INDEX OF SHEETS REV. 2019 01-10 JPS

PLAN OF PROPOSED IMPROVEMENT

FIRST ADDITION TO 1000 OAKS PHASE 6

CITY PROJECT NO. 11935
 CITY CONTRACT NO. 8198
 MUNIS NO. 11935

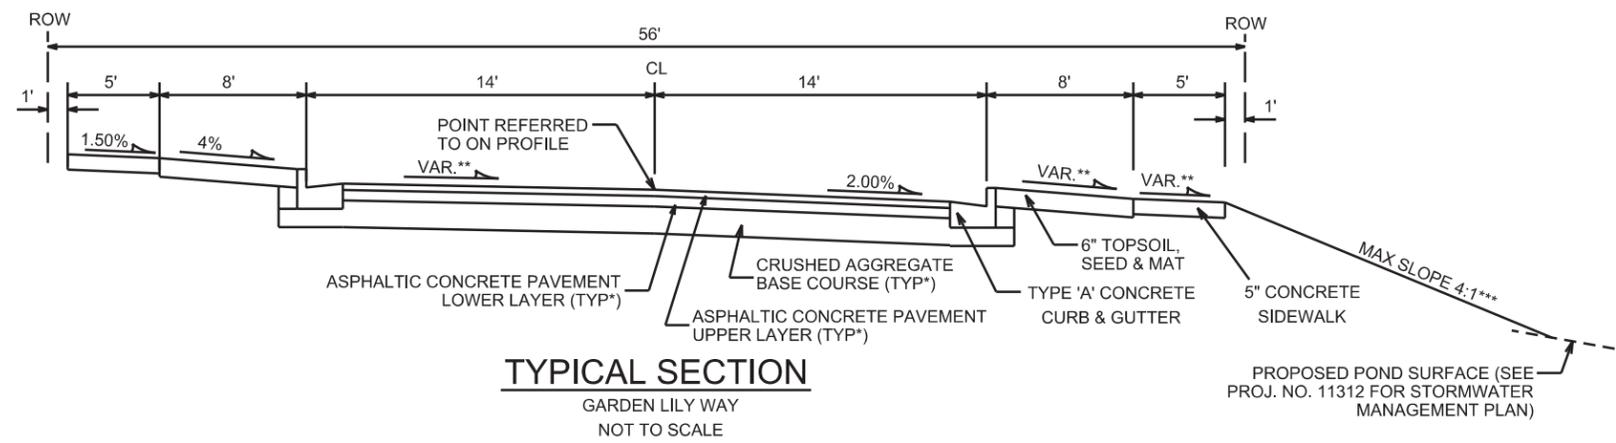
REV. NOTES:
ADDED NEW STREET
"GARDEN LILY WAY"

* GARDEN LILY WAY SHALL BE CONSTRUCTED AS TYPE 'A' PAVEMENT PER CITY OF MADISON MINIMUM PAVEMENT DESIGN †

PLAN AND PROFILE

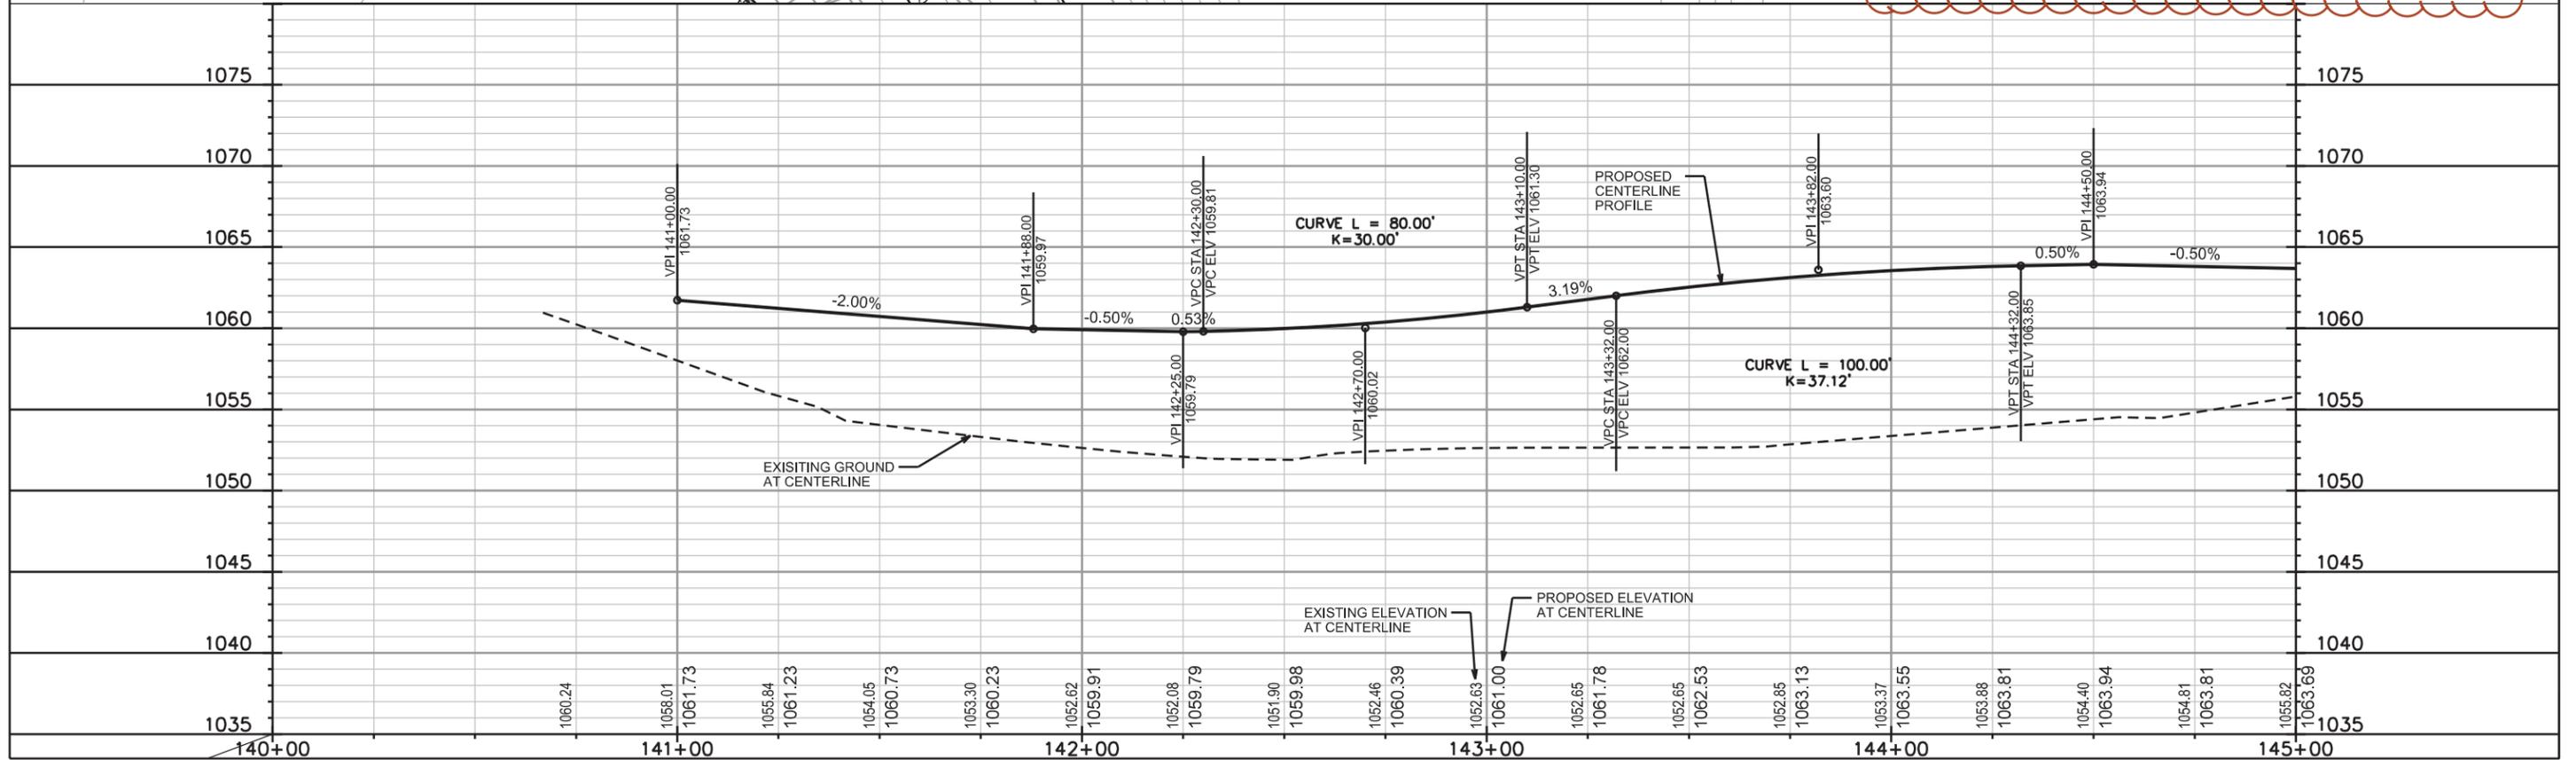
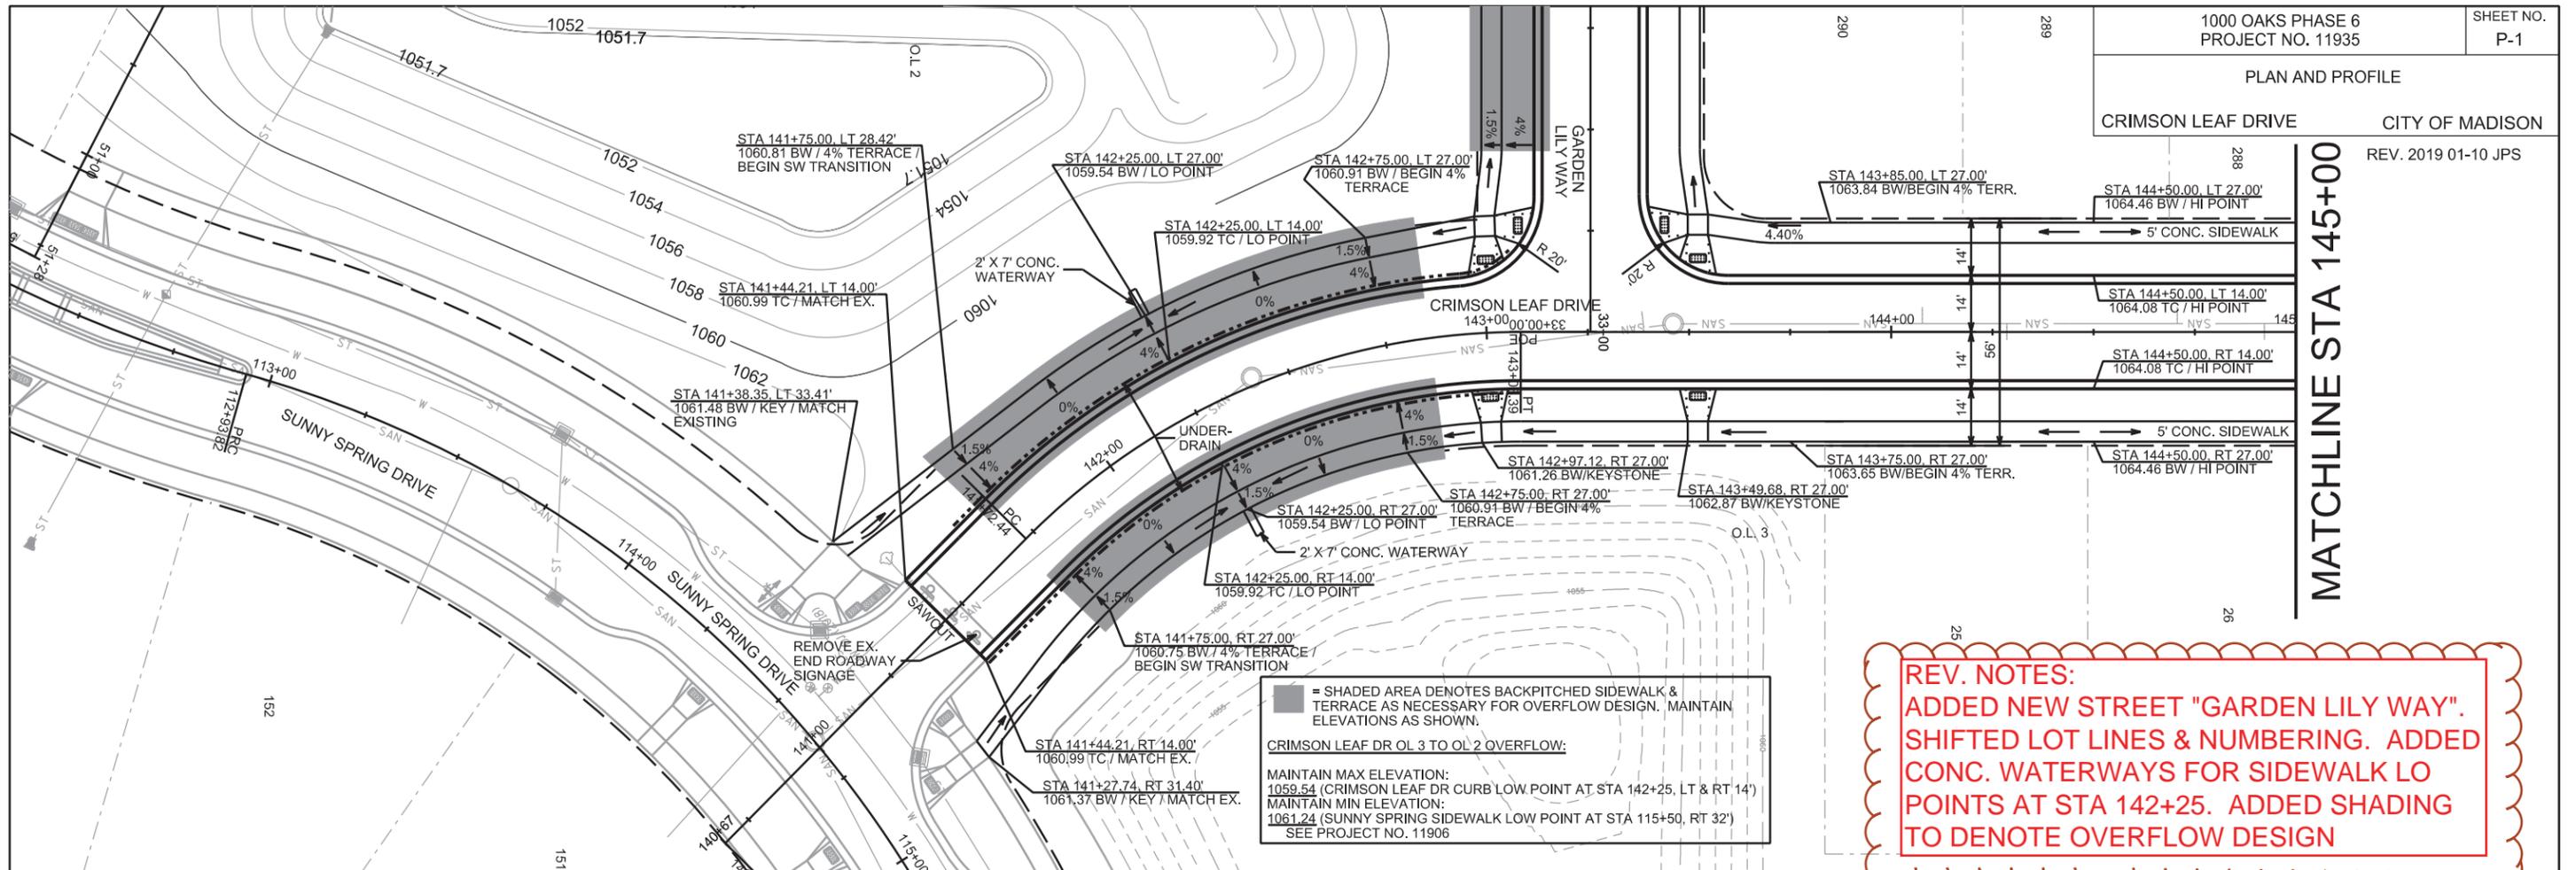
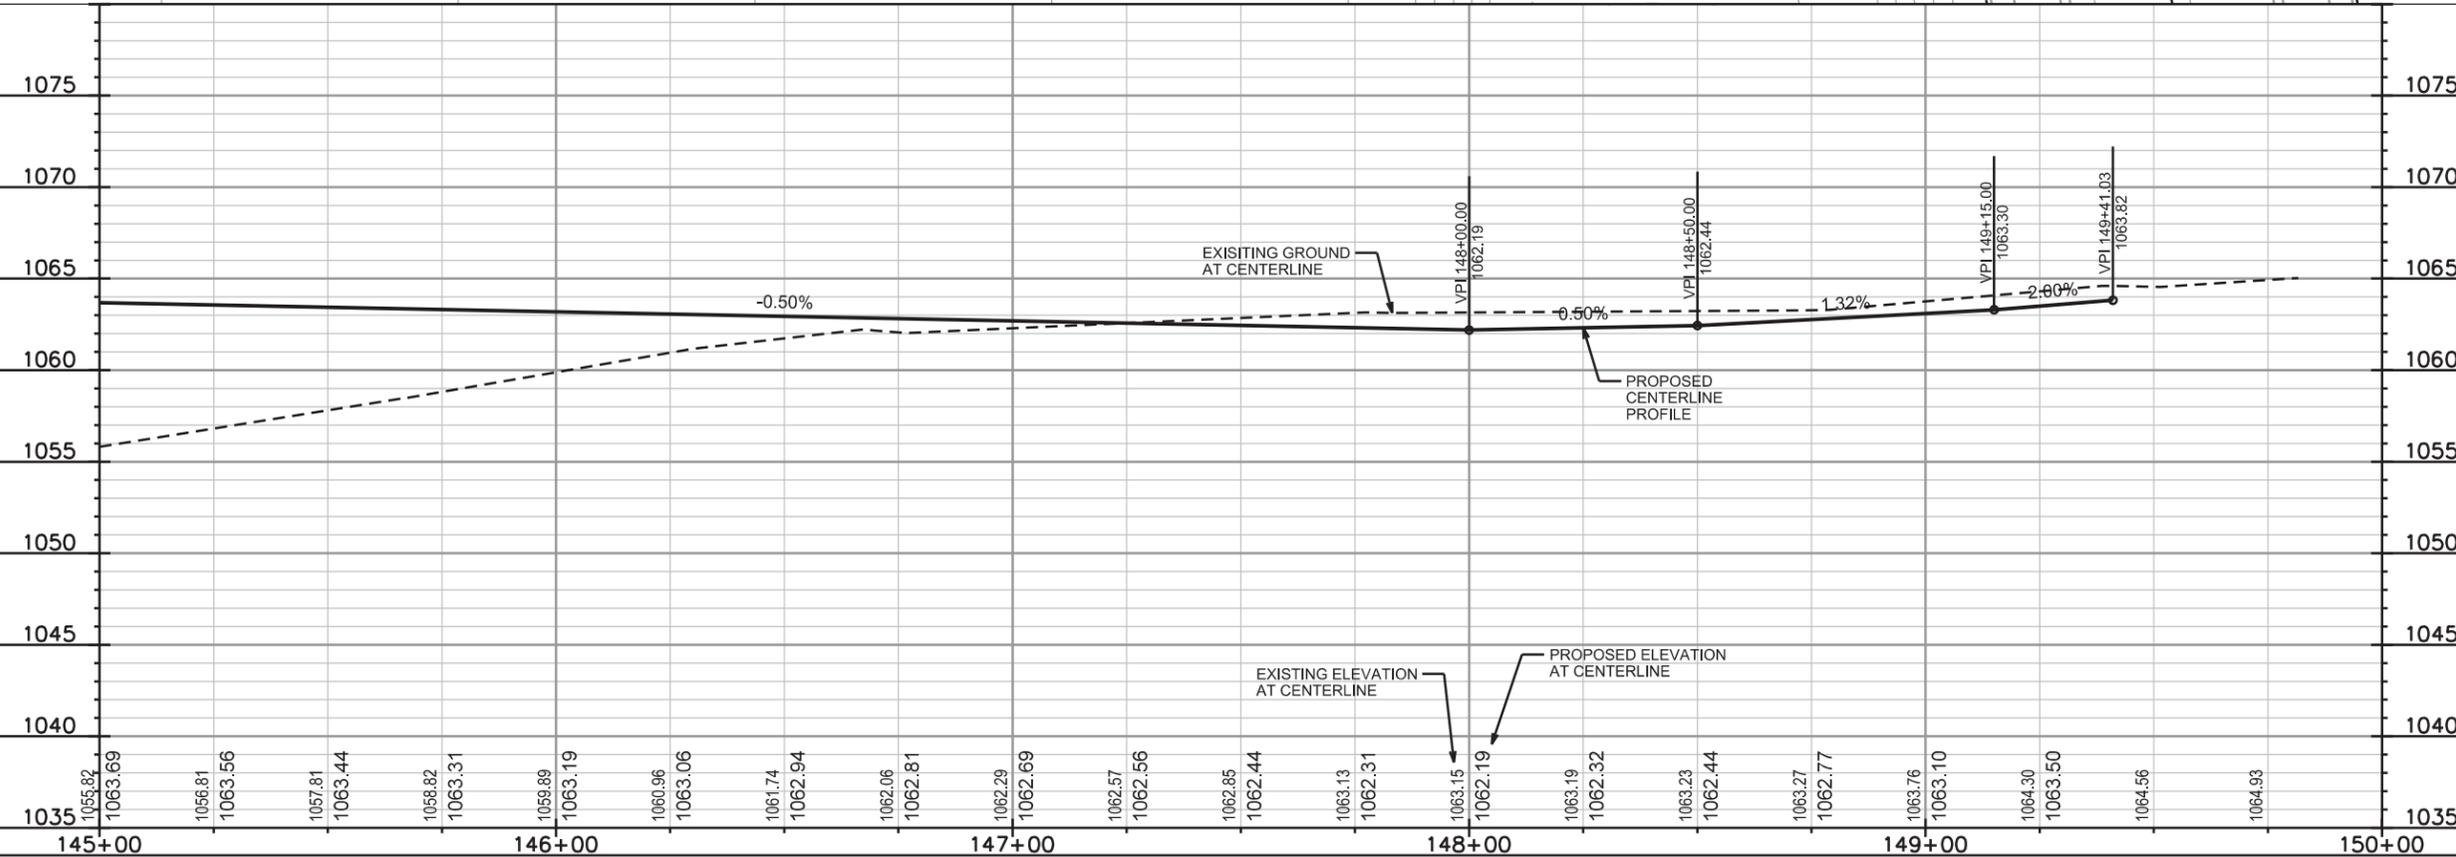
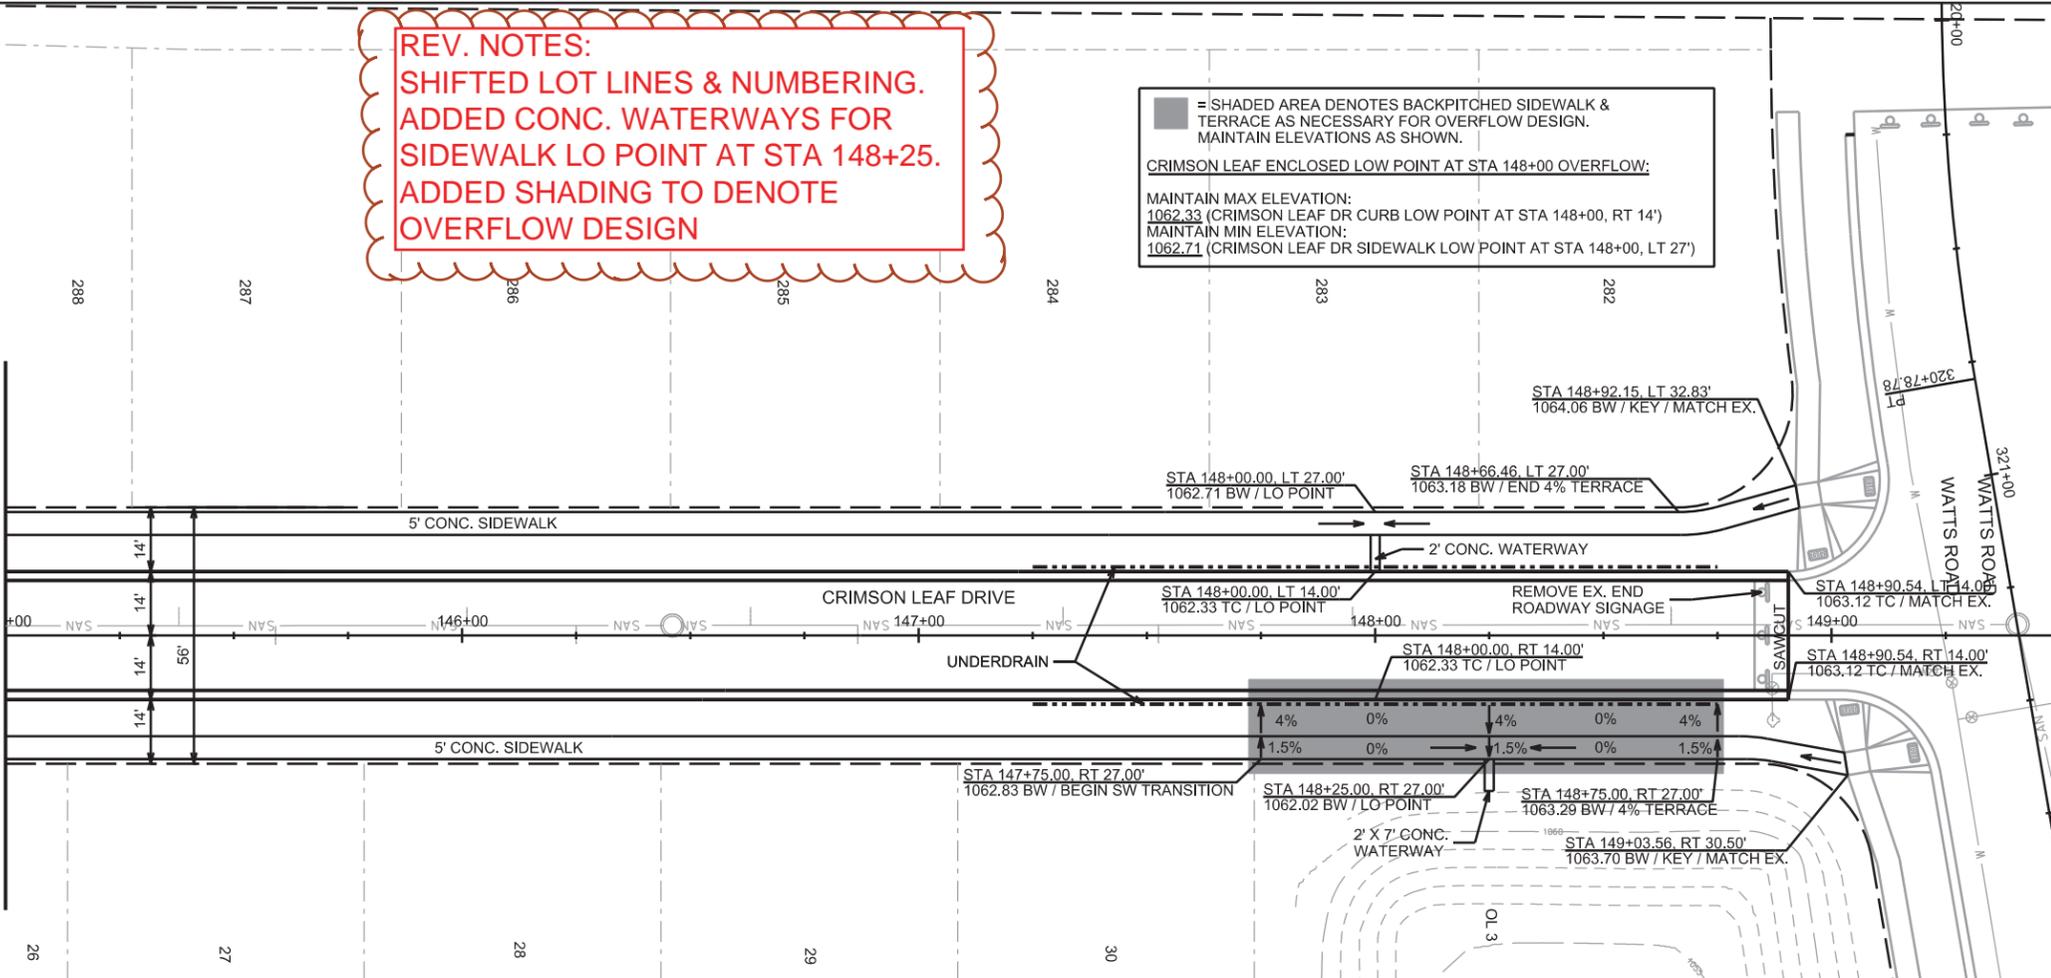
REV. NOTES:
SHIFTED LOT LINES & NUMBERING.
ADDED CONC. WATERWAYS FOR
SIDEWALK LO POINT AT STA 148+25.
ADDED SHADING TO DENOTE
OVERFLOW DESIGN

■ = SHADED AREA DENOTES BACKPITCHED SIDEWALK & TERRACE AS NECESSARY FOR OVERFLOW DESIGN. MAINTAIN ELEVATIONS AS SHOWN.
CRIMSON LEAF ENCLOSED LOW POINT AT STA 148+00 OVERFLOW:
MAINTAIN MAX ELEVATION:
1062.33 (CRIMSON LEAF DR CURB LOW POINT AT STA 148+00, RT 14')
MAINTAIN MIN ELEVATION:
1062.71 (CRIMSON LEAF DR SIDEWALK LOW POINT AT STA 148+00, LT 27')
